UNITED STATES PATENT AND TRADEMARK OFFICE

Office Action Summary	Application No. 10/711,326	Applicant(s) NAKANO ET AL.	
	Examiner THOMAS IRVIN	Art Unit 3657

DETAILED ACTION

Fig. 4 (US 3,168,836)

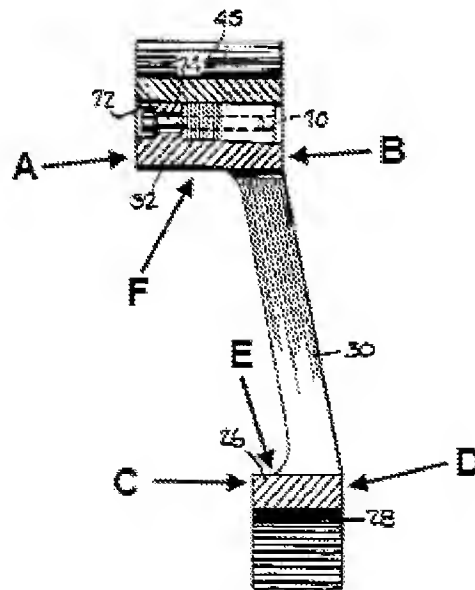
In Re claim 1, Militana discloses, with reference to fig. 4 above, a sprocket comprising: a sprocket body (20) with a first side wall (A), a second side wall surface (D), and a radially inner surface (F) facing radially inwardly; a plurality of teeth (45); a

radially inwardly and outwardly extending spline (28); wherein the spline has a free end portion (26) and a radially outer surface (E) that is disposed between the first and second side wall surfaces; and wherein the radially outer surface faces the radially inner surface. Examiner notes that the radially inwardly extending spline and radially outwardly extending spline are understood to be the protrusions and corresponding depressions of the spline.

In Re claims 3 and 4, see radially inner surface (F) in fig. 4, above.

In Re claims 5-7, see first side wall portion (24) and teeth (45), and laterally offset second side wall portion (26,30).

In Re claims 8 and 9, see first side surface (A) and side wall portion (24), and laterally offset second side wall portion (26,30) and radially inwardly extending spline (28).

In Re claim 10, see first side wall portion (24) and teeth (45), and second side wall portion (26) and radially inwardly extending spline (28) forming a composite spline.

In Re claim 11, see radially inwardly extending spline (28) and second side wall portion (30).

In Re claim 13, Militana discloses, with reference to fig. 4 above, a sprocket comprising: a sprocket body (20); a plurality of teeth (45); a radially inwardly and outwardly extending spline (28), wherein the spline has a root portion (30,32) and a radially inner portion (26) having a side wall (C,D); wherein the spline terminates at a

free end (26); and wherein a thickness of the radially inner portion (26) is greater than a thickness of the root portion (30). Examiner notes that the radially inwardly extending spline and radially outwardly extending spline are understood to be the protrusions and corresponding depressions of the spline.

In Re claim 14, see side wall (A), first side wall portion (24), teeth (45), and root portion (32).

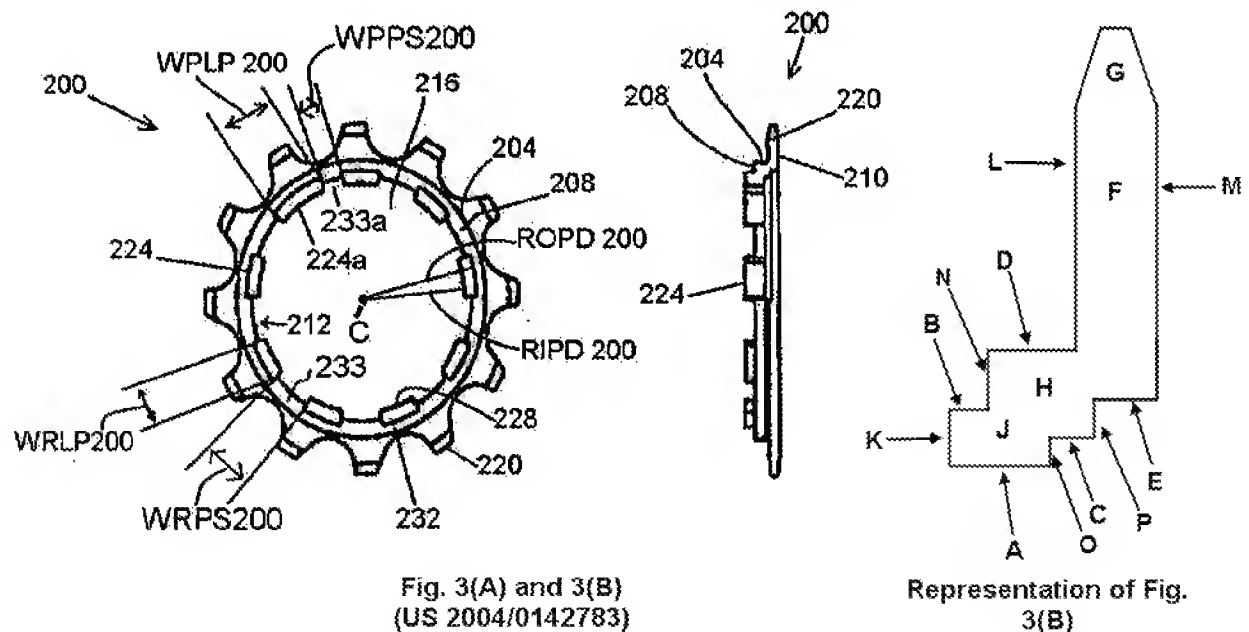
In Re claim 13, Kamada et al. disclose, with reference to figs. 3A and 3B above,
a sprocket comprising: a sprocket body (200,F); a plurality of teeth (G); a radially

inwardly and outwardly extending spline (A, C), wherein the spline has a root portion (H) and a radially inner portion (J) having a side wall (K, O); wherein the spline terminates at a free end (K); and wherein a thickness of the radially inner portion (J, K-O) is greater than a thickness of the root portion (H, N-O). Examiner notes that the radially inwardly extending spline and radially outwardly extending spline are understood to be the protrusions and corresponding depressions of the spline.

In Re claim 14, the sprocket has a side wall (M) and first side wall portion (F), wherein the plurality of teeth (G) extend from the first side wall portion, and wherein a thickness of the first side wall portion (L-M) substantially equals a thickness of the root portion (H, N-L, L-M).
